NORTH RIDGE VILLAGE ADDITION
PROJECT NAME

VILLAGE CIRCLE
SHEET TITLE

JANUARY 2006 04394 12 / 34
DATE JOB NO. SHEET/OF

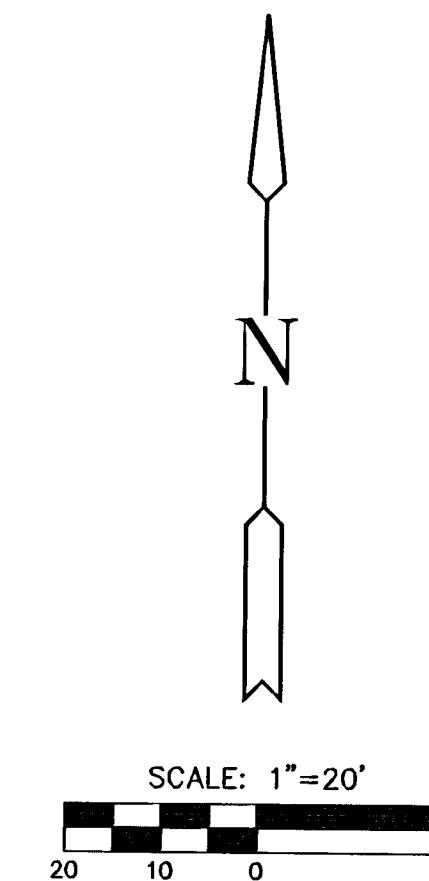
~~INSTALL R4-7 &
OM1-3 SIGNS~~

INSTALL R1-1 SIGN
--	-------------------
